APPENDIX A
AGENCY CORRESPONDENCE

ENVIRONMENTAL REVIEW

Project number: NYC EDUCATIONAL CNSTRCTN FUND / 16ECF001M

ECF East 96th Street, Manhattan
City Planning Commission Response
June 1, 2017

FAILURES - IN SUMMARY

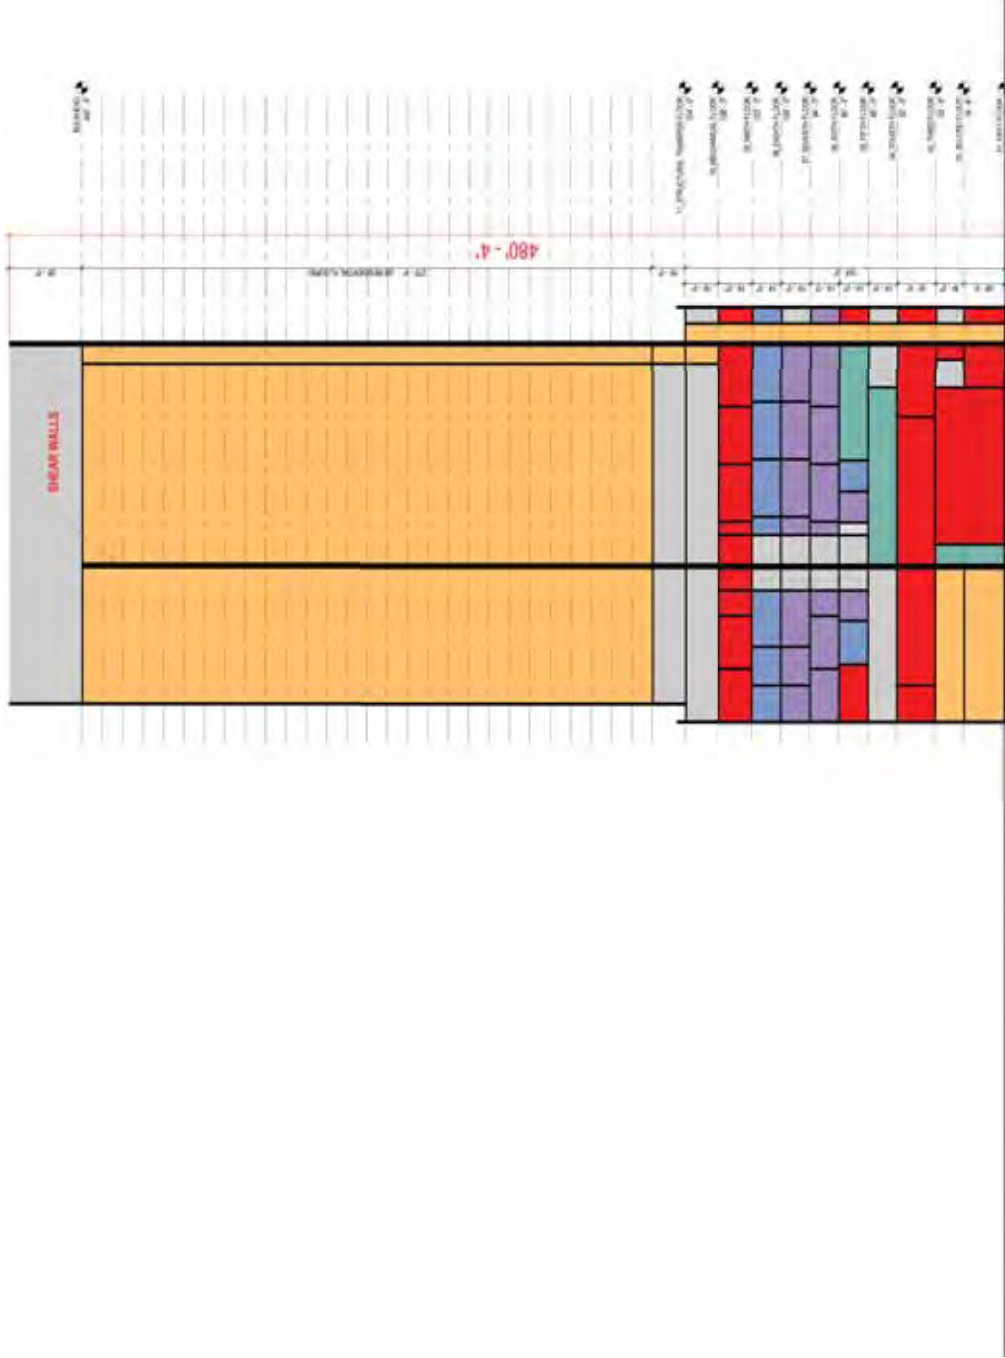
- SCHOOL BUILDING HEIGHT IS INCREASED TO 9 STORIES (FROM 8 STORIES)
- BUILDING EFFICIENCY DECREASES
 - SCHEME B - 48% INEFFICIENCY
 - CURRENT DESIGN - 40% INEFFICIENCY
- COMPROMISES TO SCA PROGRAM REQUIREMENTS INCLUDE:
 - AUDITORIUM REDUCED TO 300 SEATS (FROM 450)
 - COMPETITION GYMNASIUM REDUCES PERIMETER SAFETY AREA BEHIND BASKETBALL HOOPS TO 7'-6" (FROM 10')
- SECURITY PROBLEM: NUMEROUS UNSUPERVISED BLIND CORRIDORS
- UNDERSIZED SPACES: 3 LOCKER ROOMS, EXERCISE ROOM AND HEALTH INSTRUCTOR (ALL PHYSICAL EDUCATION PROGRAM), UTILITIES
- INEFFECTIVE PROGRAM ADJACENCIES AND LOCATIONS:
 - GENERAL SUPPLY/RECEIVING IS ON THE 3RD FLOOR, REQUIRED TO BE ON THE FIRST FLOOR
 - PHYSICAL EDUCATION PROGRAM OVER 3 FLOORS
 - FEMALE LOCKER ROOM 2 FLOORS ABOVE GYM
 - GUIDANCE SUITES ARE ORPHANED FROM THEIR HIGH SCHOOLS
- ENTRANCES DO NOT MEET REQUIREMENTS (NO SECOND STUDENT ENTRANCE)

NOTE: RED INDICATES SPACES THAT DO NOT MEET SCA PROGRAM AREA REQUIREMENTS

FIRST FLOOR PLAN WITH SITE PLAN

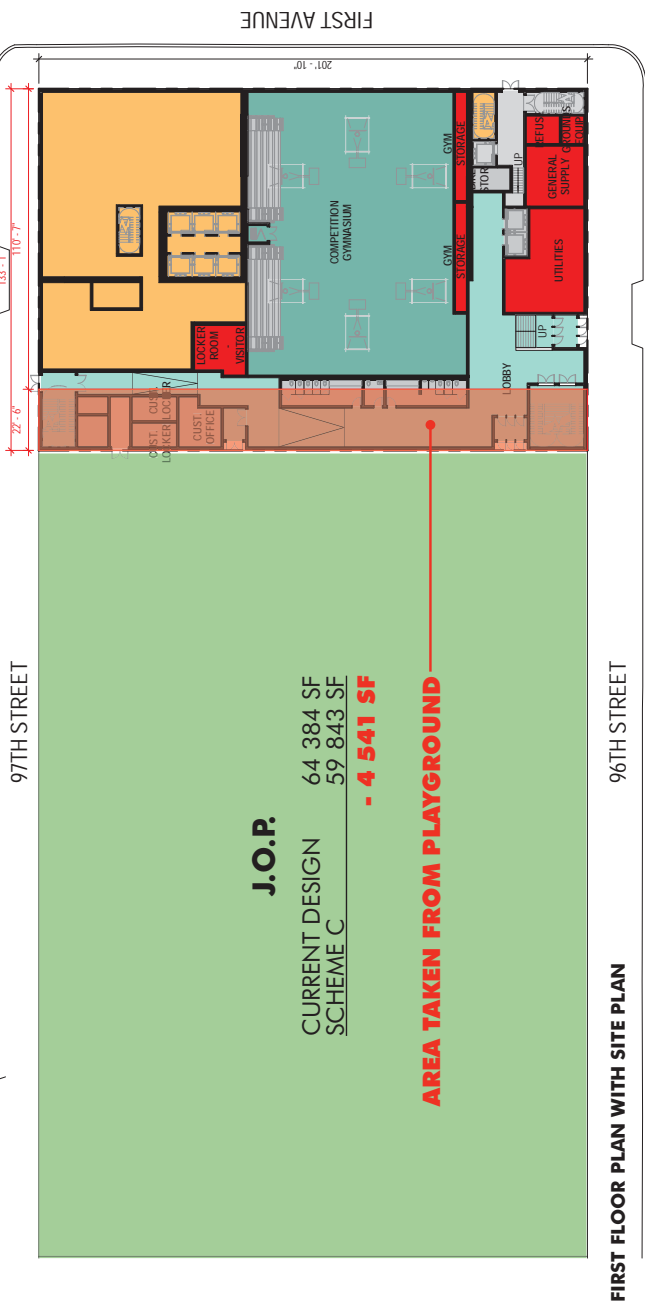
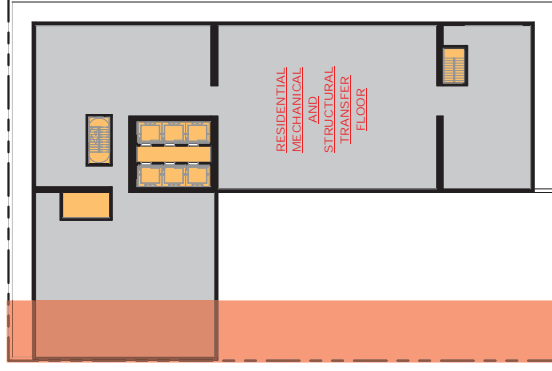
FAILURES

- SECURITY CONCERN: NUMEROUS UNSUPERVISED BLIND CORRIDORS ON 1ST, 2ND AND 3RD FLOORS
- COMPROMISES TO SCA PROGRAM REQUIREMENTS INCLUDE:
 - TECHNOLOGY LAB
 - 2 TEACHER WORKROOMS
- UNNECESSARY DOUBLE HEIGHT SPACE IN LIBRARY AND ART ROOMS TO ACCOMMODATE REQUIRED SEPARATION FOR THE 2 HIGH SCHOOL PROGRAMS

Option 1: Overbuild and keep schools the same

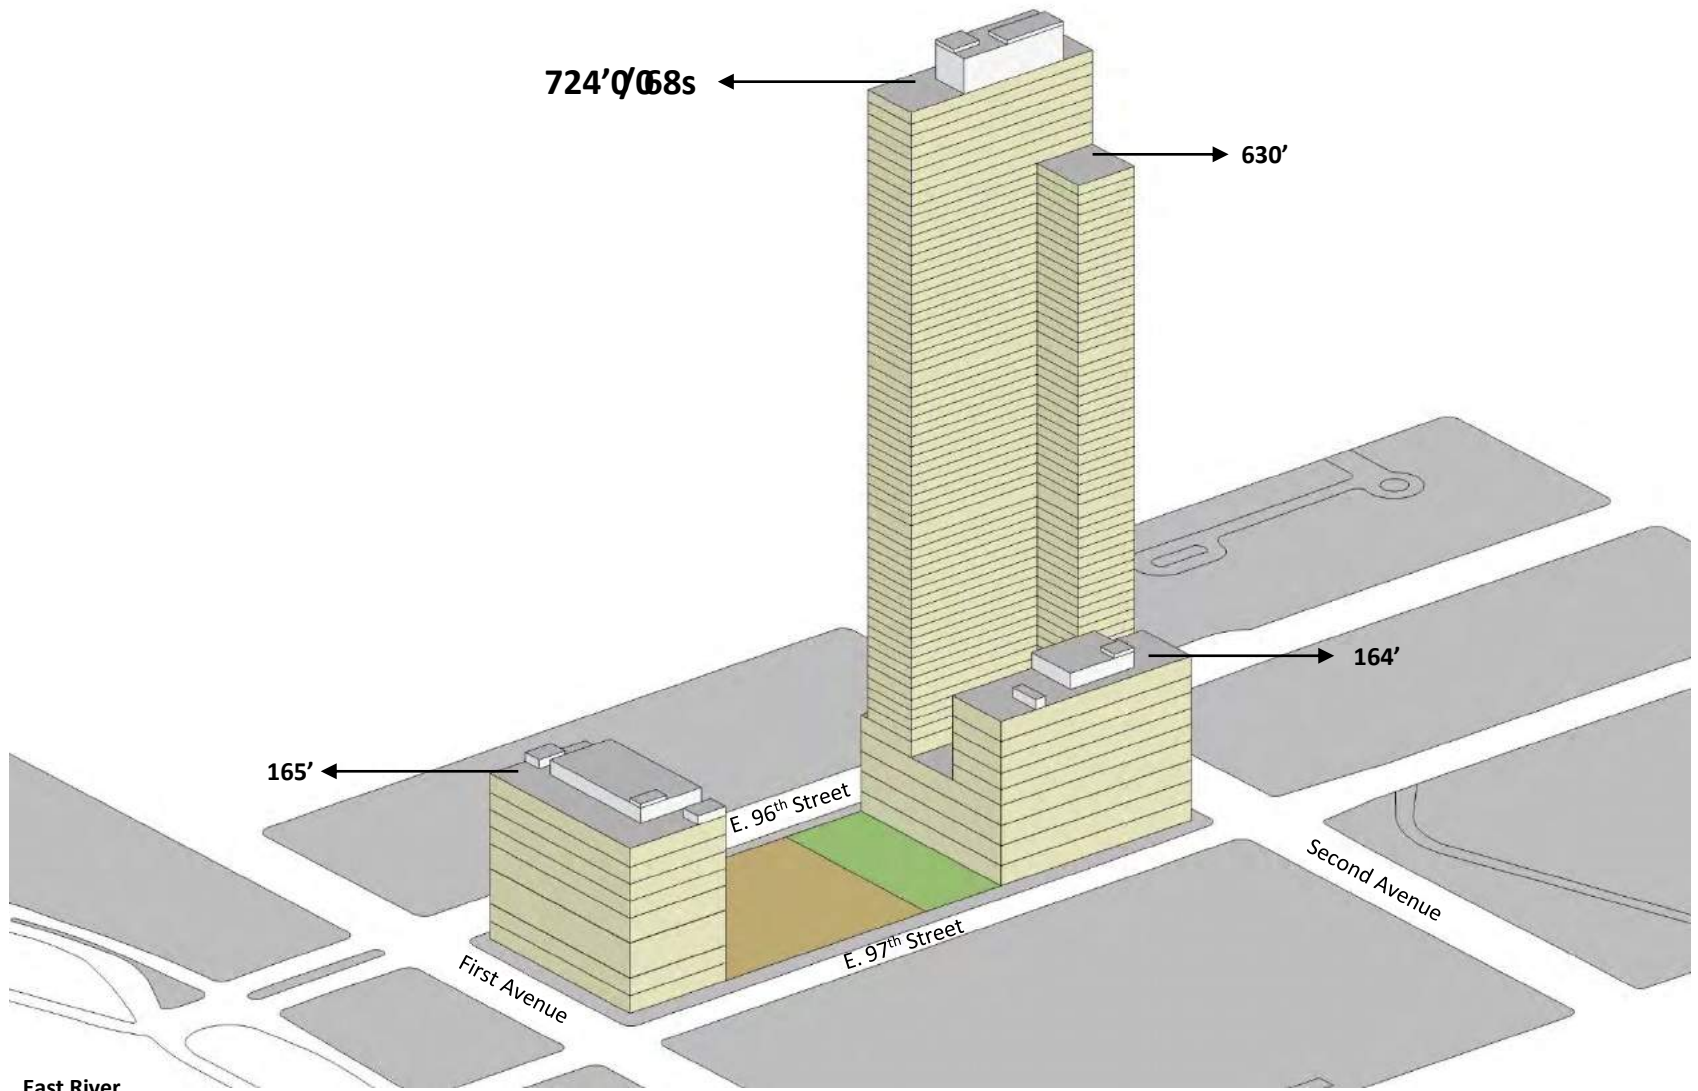
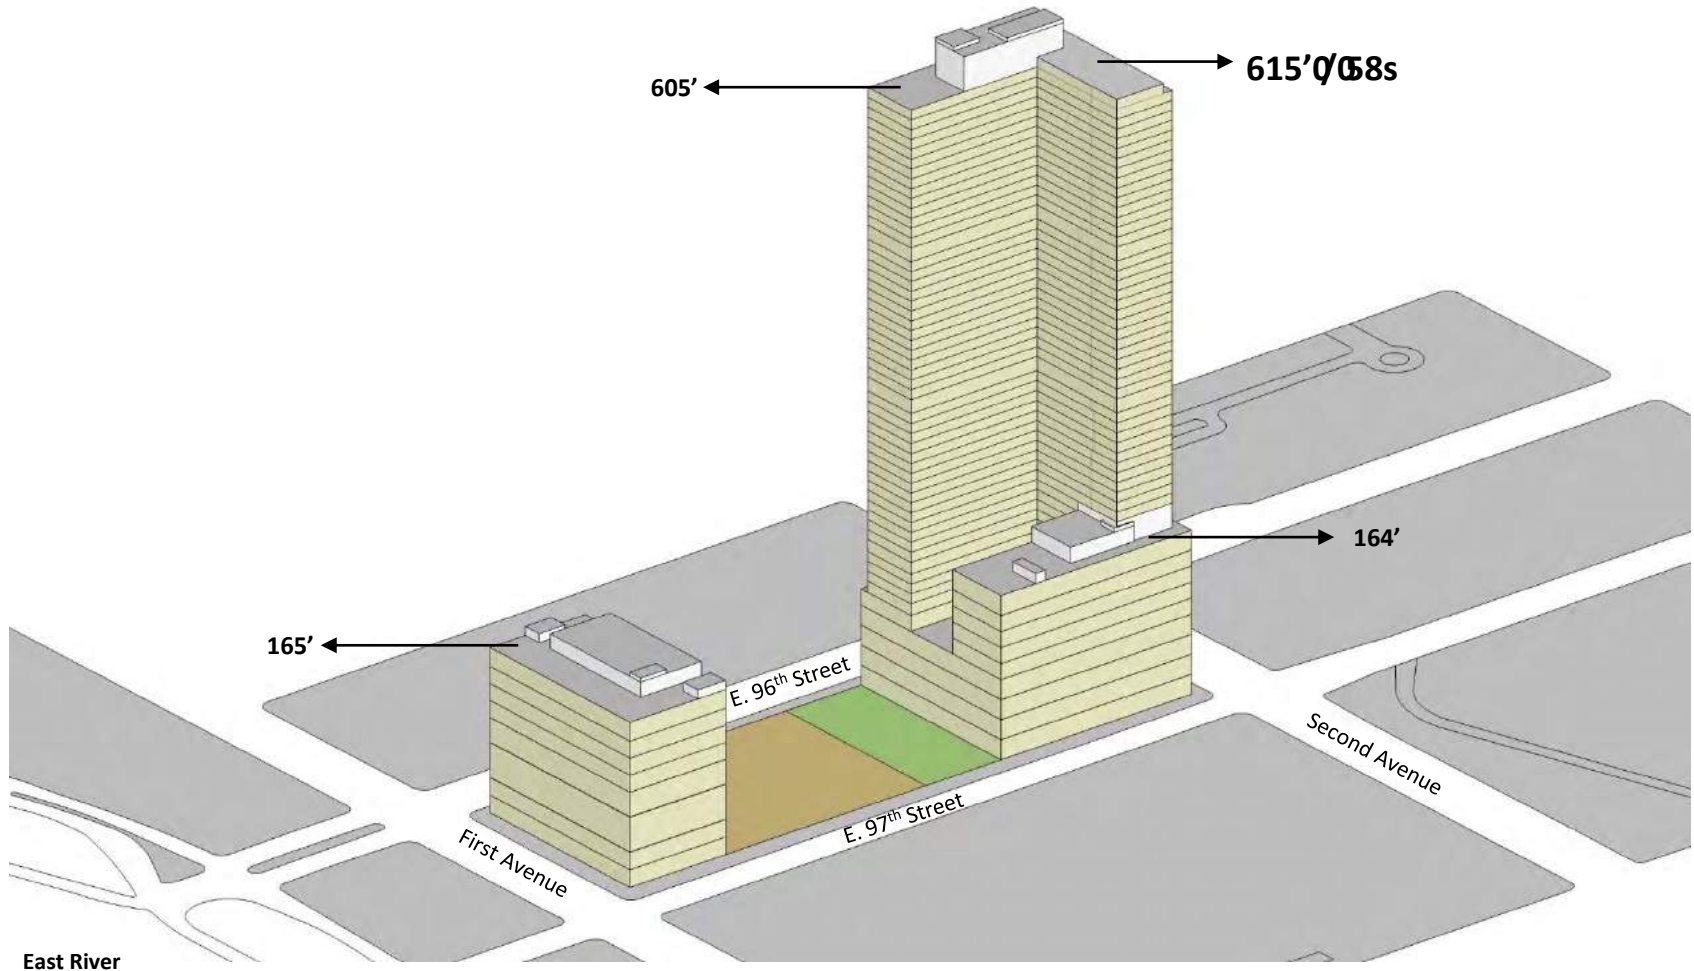
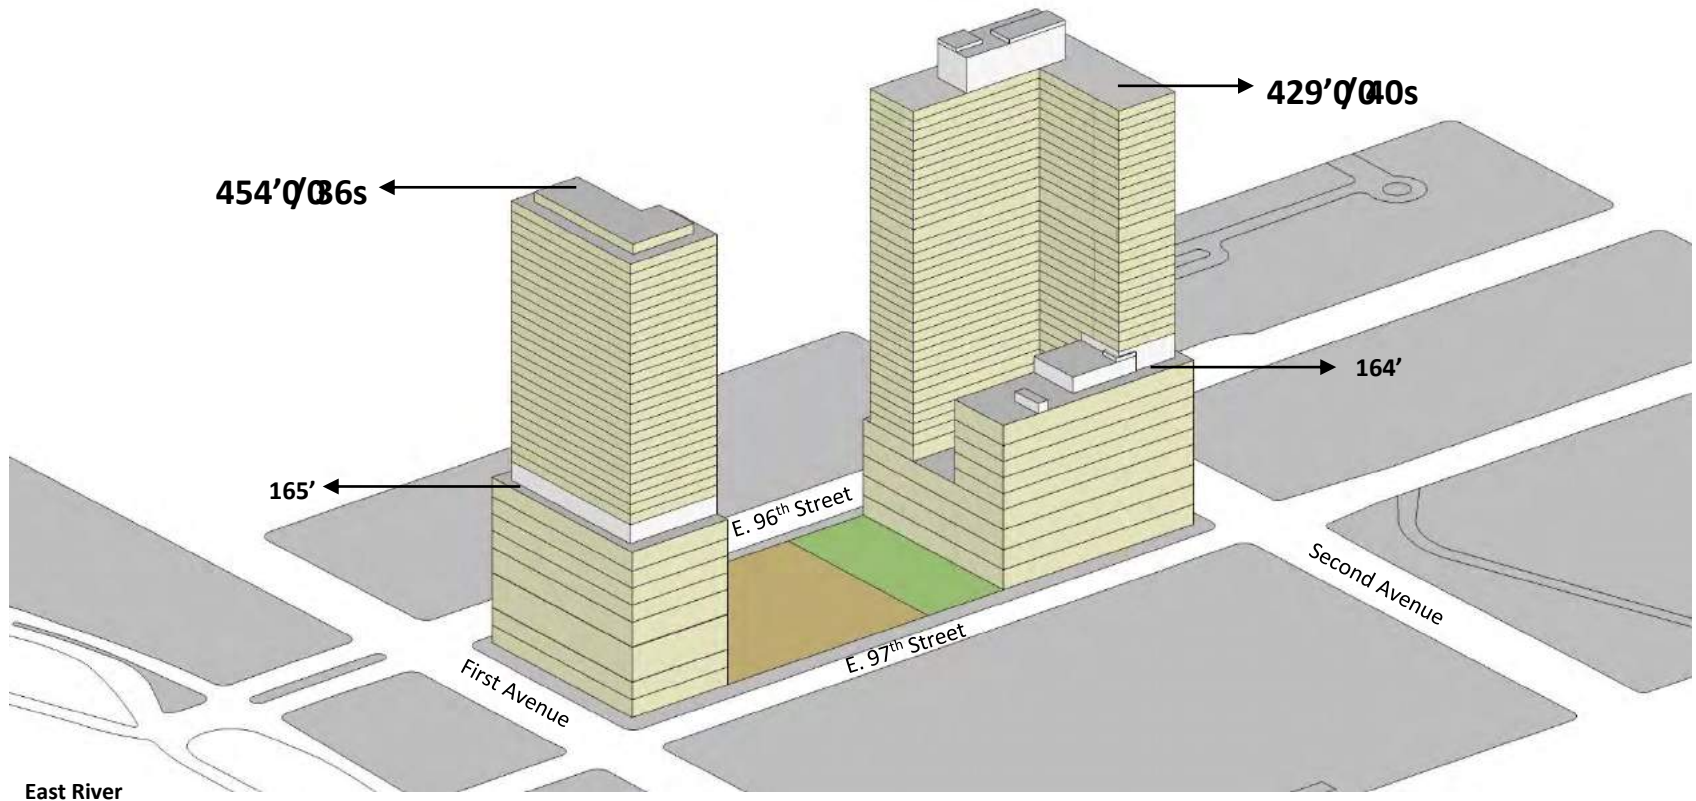
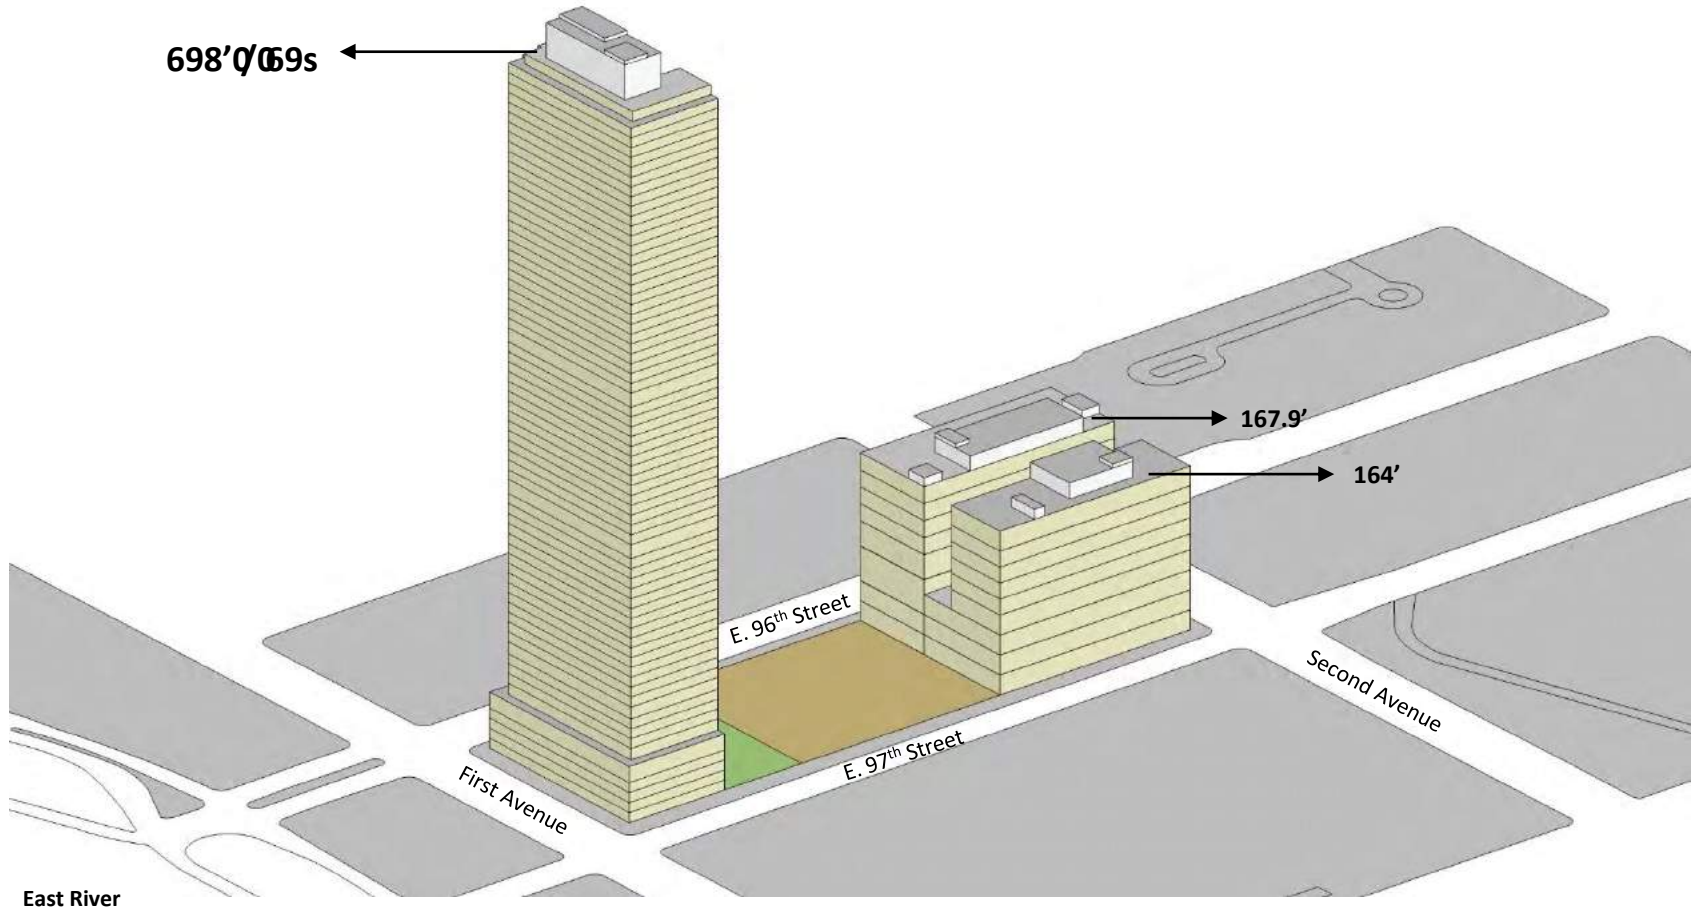
Expands the building over part of Co-op Tech, loses 10 stories

Compromises the school, but brings buildings down to ~450 feet

Still huge and a poor place for the building (flooded during Sandy)

The overbuild option is the simplest way to reduce height without compromising the schools
